## RECALL SERVICE BULLETIN

520

Spartan Motors has decided that a defect relating to motor vehicle safety exists in specific motorhomes built on Spartan chassis. In response, Newmar Corporation is issuing recall NHTSA# 18V 307, TC# 2018-253.

## Recall Service Bulletin

**FIG. 2-1**

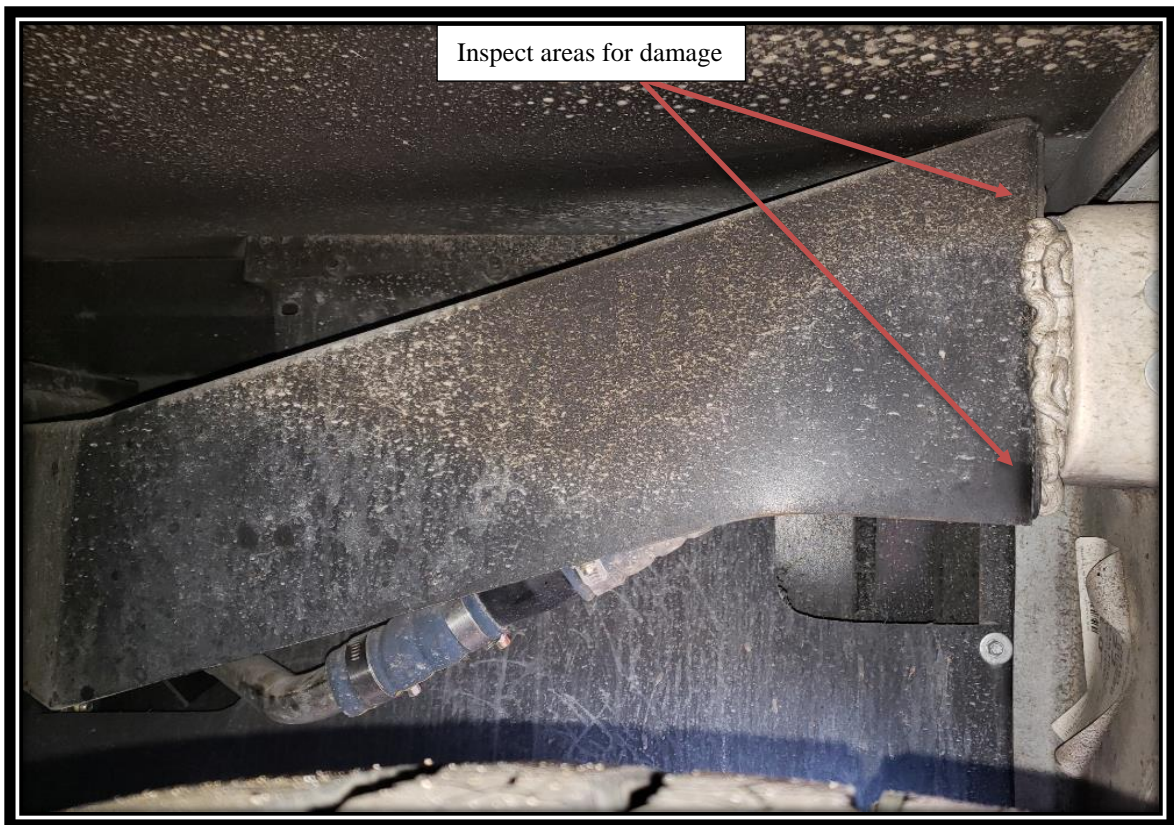
- b. If tire damage is present, contact Spartan Customer Service (tire is not part of service kit)  
Tel: 855-589-9836
  5. Locate DEF fill support mounted in rear of tag axle wheel well and inspect for damage. Refer to FIG. 2-1.
    - a. Pay special attention to bracket and body interface at location of plastic DEF fill.
    - b. If damage has occurred to plastic DEF fill it should be replaced.
    - c. If DEF fill is damaged contact Customer Service (P/N 908-1272-01 {PIA in 2772-LL2-001} is not part of the service kit)

**FIG. 3-1**

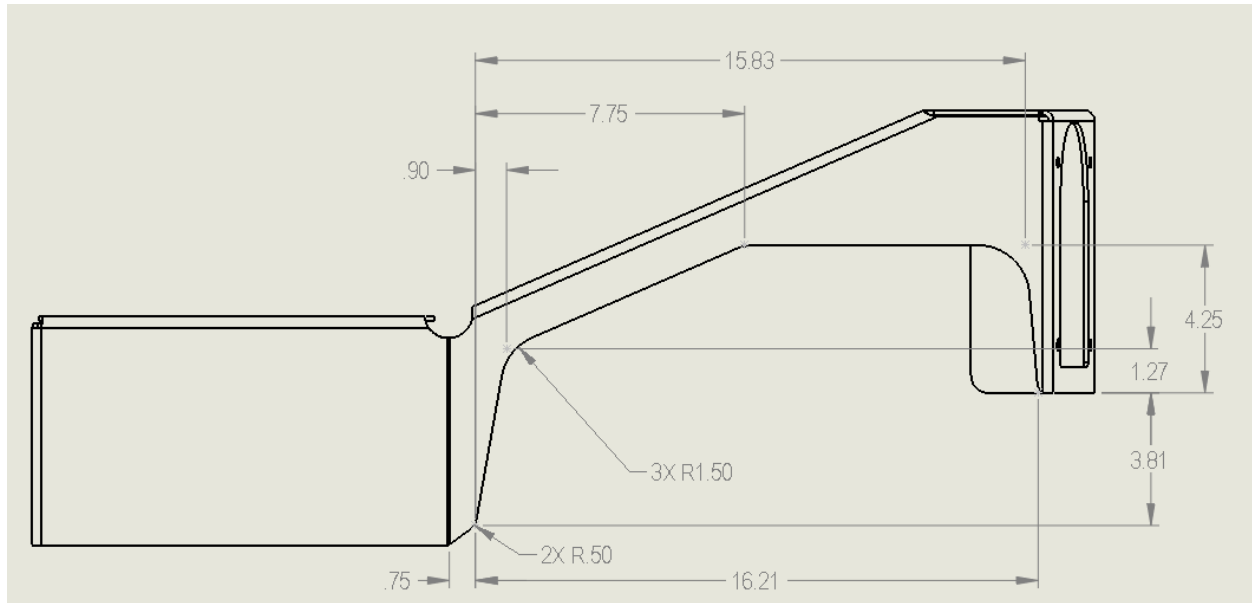
6. Using dimensions provided, layout cut pattern. Refer to FIG 3-1.
7. Carefully cut bracket, cut-off wheel or Sawzall preferred. Remove and properly dispose of cutoff portion of bracket. **Use caution not to damage the DEF fill and hose.**

FIG. 4-1

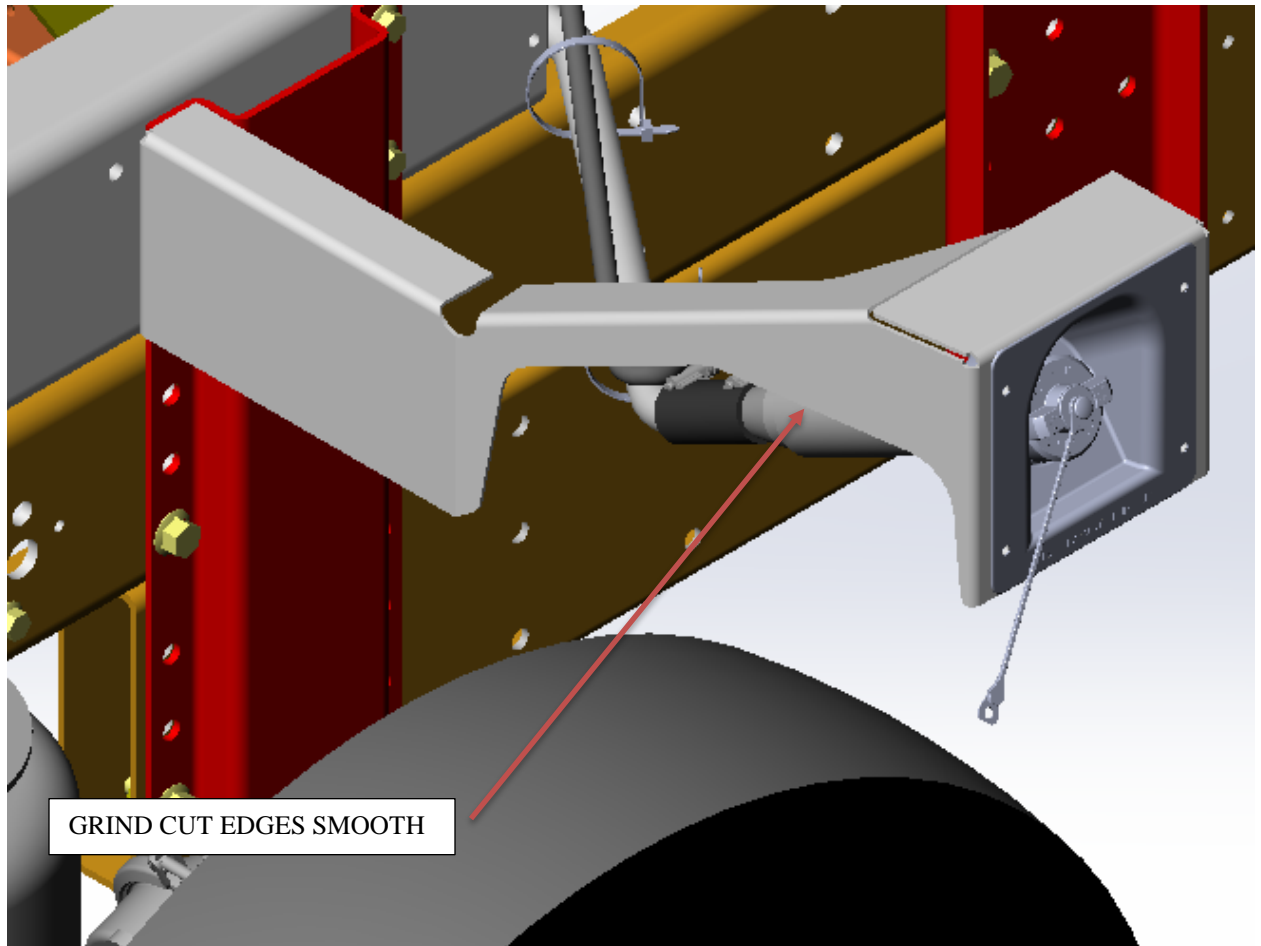
8. Grind cut edges of bracket remaining on coach, smooth. Refer to FIG. 4-1.
9. Paint bracket remaining on coach, using black paint. (Paint not included in service kit)
